Access Compliance Report

Public Rights-of-Way

(Pedestrian Signals)

Intersection ID: N/A	Main Street:	Cross Street: N/A	Location: N/A
ADA ID: 749C890E94C7	Signal Type: One Push Button-APS	Overall Compliance: No	Severity Score: BTN 1: N/A BTN 2: N/A No BTN: N/A
Codes/Mitigation Info/Possible Solution		Field Measurements/Component Compliance

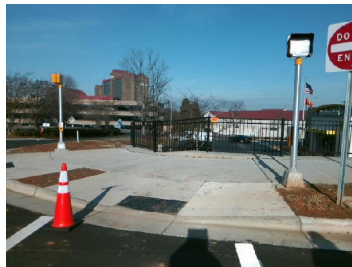
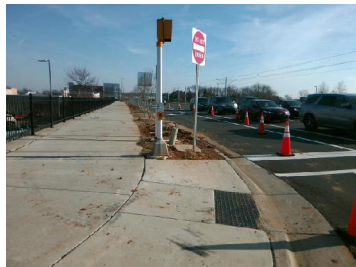
PROW/ADA: R404.2, R404.3, R404.7.2,
R209.1, MUTCD 4e.10

N/A	B 1 FWD Approach Width (in)	N/A	N/A	B 2 FWD Approach Width (in)	N/A
N/A	B 1 FWD Approach Obstruction?	Yes	N/A	B 2 FWD Approach Obstruction?	N/A
N/A	B 1 FWD Approach Obstruction Dist (in)	4.0	N/A	B 2 FWD Approach ObstructionDist (in)	N/A
N/A	B 1 PARA Approach?	Yes	N/A	B 2 PARA Approach?	N/A
N/A	B 1 PARA Approach Constrained?	Yes	N/A	B 2 PARA Approach Constrained?	N/A
Yes	B 1 PARA Approach Reach (in)	8.0	N/A	B 2 PARA Approach Reach (in)	N/A
No	B 1 PARA Approach Width (in)	48.0	N/A	B 2 PARA Approach Width (in)	N/A
N/A	B 1 PARA Approach Obstruction?	Yes	N/A	B 2 PARA Approach Obstruction?	N/A
N/A	B 1 PARA Approach Obstruction Dist (in)	4.0	N/A	B 2 PARA Approach ObstructionDist (in)	N/A
No	B 1 Clear Floor Space Slope (%)	5.7	N/A	B 2 Clear Floor Space Slope (%)	N/A
No	B 1 Clear Floor Space XSlope (%)	4.5	N/A	B 2 Clear Floor Space XSlope (%)	N/A
N/A	B 1 PAR Slope (%)	N/A	N/A	B 2 PAR Slope (%)	N/A
Yes	B 1 Height (in)	37.0	N/A	B 2 Height (in)	N/A

Possible Solutions: Remove & Replace
Replace APS Button With New APS Button.
Remove and Replace Clear Space.
